PLANNING COMMISSION STAFF REPORT
Administrative Item
Conditional Building and Site Design Review

111 South Main
PLNPCM 2013-00501
107 (111) South Main
September 11, 2013

Steven Sobel, representing Hamilton Partners, is requesting a Conditional Building and Site Design Review for a building to be located at 107 South Main Street (the new address will be 111 South Main). The Planning Commission has final decision making authority for Conditional Building and Site Design Review.

WEST ELEVATION

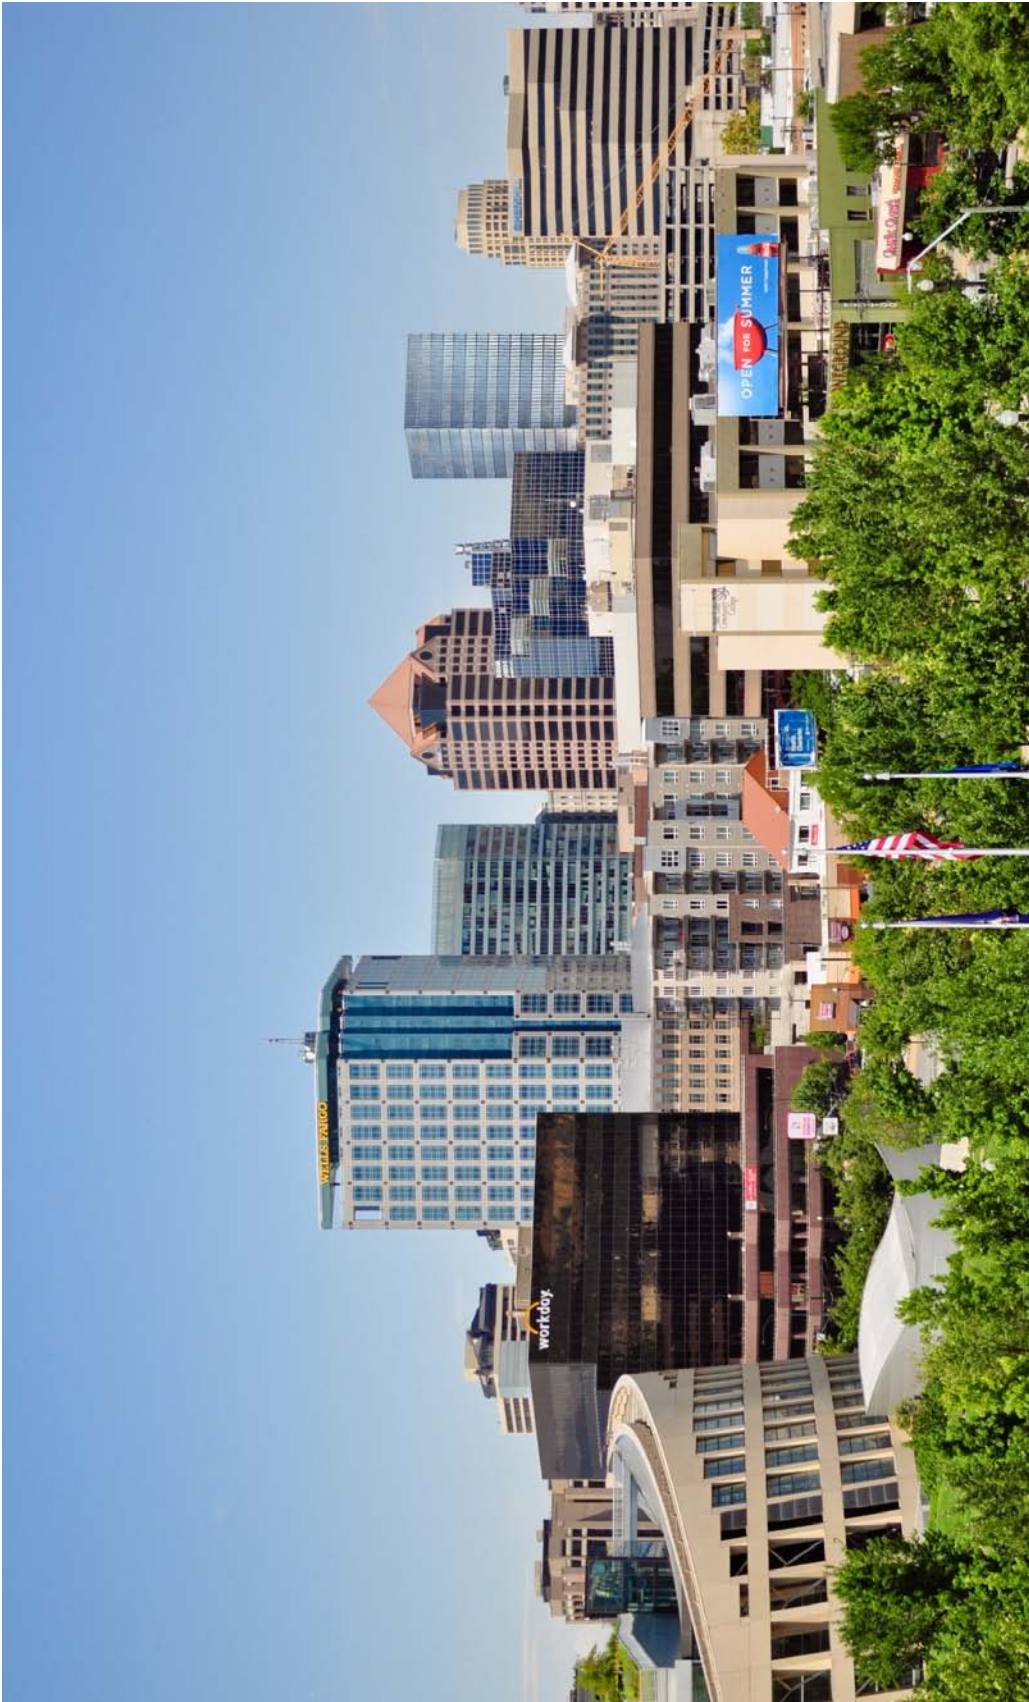
Finding: The design of the building is a glass tower with a façade of varying detailing and texture. The additional height of the structure will allow for the screening of roof top equipment. Although the roof space is not open to the public, the additional height provides for a translucent parapet wall that may be back-lit, creating the effect of a lantern on the skyline. This is similar to the roof treatment of the 222 South Main tower.

Finding: The additional height is for a parapet wall. This design standard is intended to encourage visual interest for prominent buildings on the skyline. Although the parapet does not provide complicated architectural design, it is consistent with the architecture of the building and will provide an opportunity to be a beacon or lantern on the skyline. The glass lantern is a modern interpretation of a traditional cornice, where lighting is used as the method of delineating the top of the tower.
